**LEGAL ADVERTISEMENT
HISTORIC PRESERVATION BOARD
CITY OF PORTLAND
Public comments will be taken at all meetings**

On Wednesday, June 4, 2014 at 5:00 p.m., the Portland Historic Preservation Board will meet in Room 209 of City Hall to review the following items:

**HISTORIC PRESERVATION BOARD
CITY OF PORTLAND, MAINE**

**PUBLIC HEARING
1 CARROLL STREET**

1 X 6 PAINTED SHIPLAP

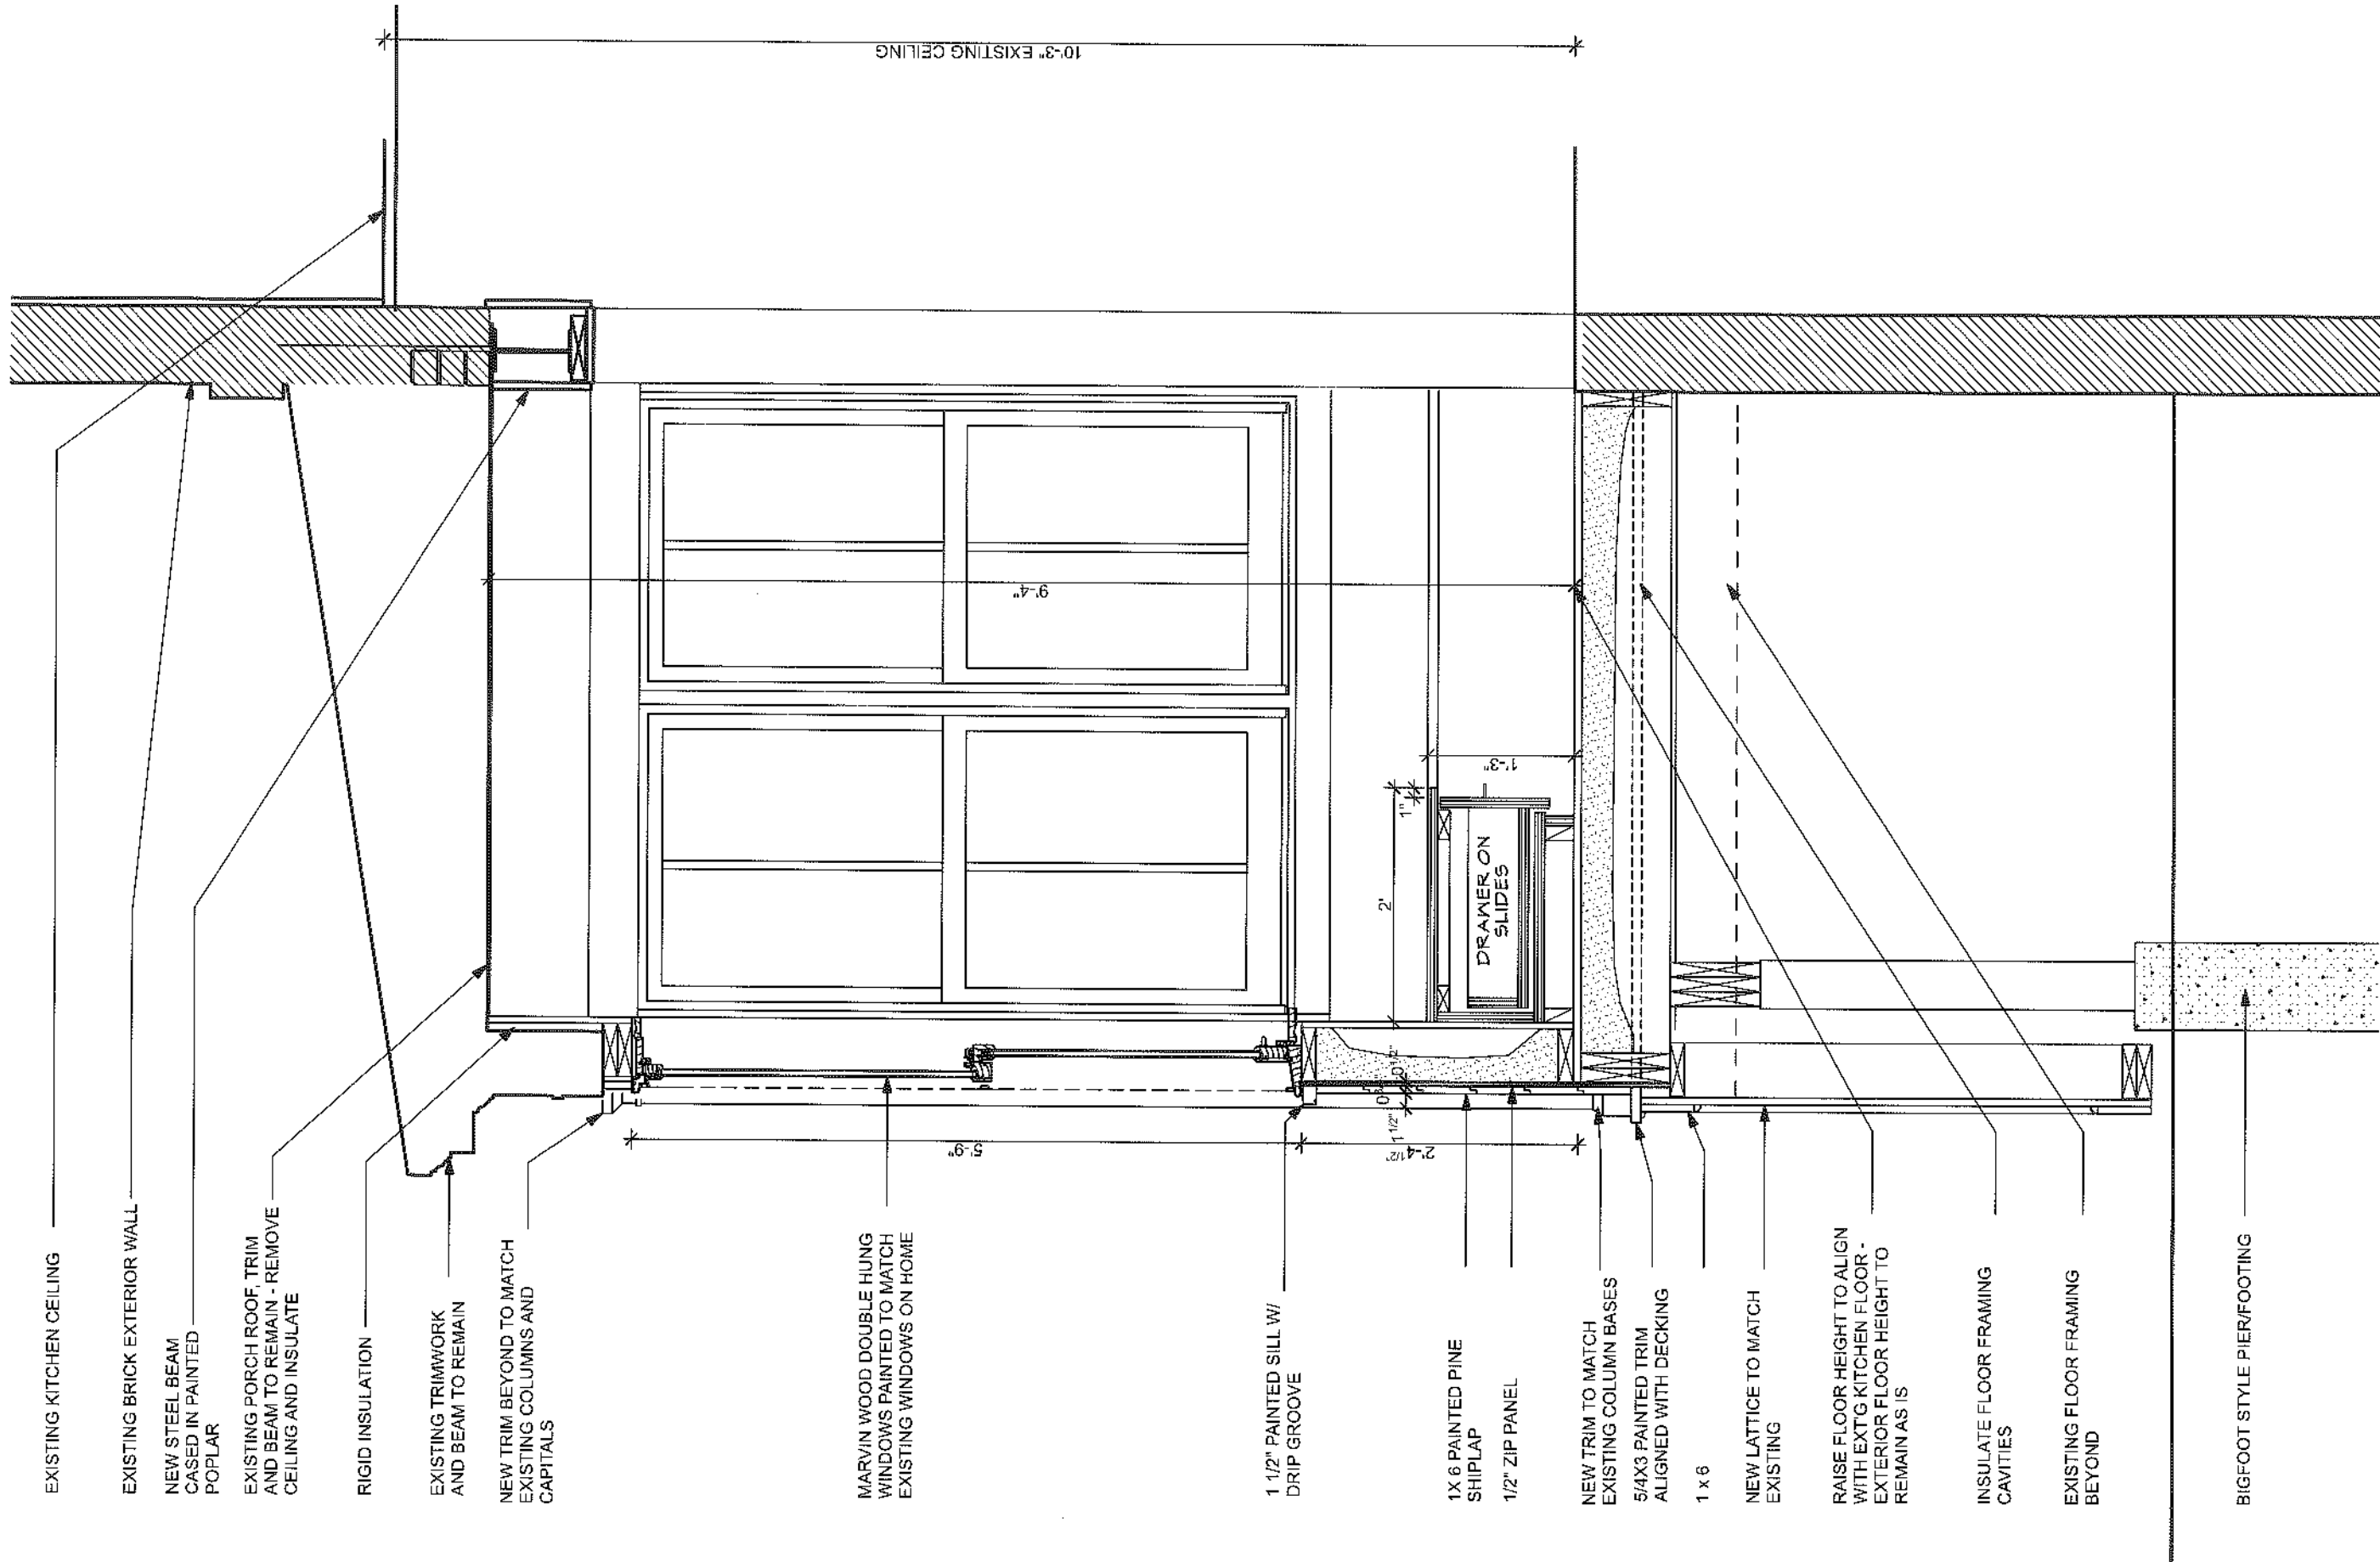
The new elevations, wall section, and narrative present more changes in response to the concerns where the Board came closest to consensus. Inside, the half columns at the north and south ends of the removed wall, along with the supporting beam, are all proposed to be wrapped with painted wood; in the last proposal the tile backsplash surrounded the north post as well; now the tile wrapping the painted north post has been eliminated. On the exterior columns, bases, and capitals on the prominent Thomas Street face appear to match the existing except that the columns and window sills are proposed to have greater depth than in the last iteration of the plans. In conjunction with proposing flush painted board siding on the north wall, the east wall is shown with the same treatment in the latest elevation.

On the exterior of the Thomas Street (east) wall, Board members are presented with somewhat more robust columns and window sills, and must decide whether the current proposal is strong enough to relate to the house appropriately. It is perhaps worth noting that the width of the columns, their capitals, and the bases all match the existing columns of the porch, but the columns have been deepened to stand out more, and they are more pronounced in that façade with the addition of the middle column added for the version of the plans reviewed on March 19. The Board may want to discuss whether they seek details that are bolder than those on the existing porch, or should the existing models be emulated as past changes that have acquired significance in their own right. Staff also wonders whether the thickness of the window sill should be increased to have a stronger presence.

On the north wall, the combination of a narrow window akin the main face of the porch enclosure and simple, smooth siding may come closer than any of the previous plans to a compatible solution for this face. Staff believes the Board will be comfortable with the proposal of Marvin wood windows, rather than a clad version.
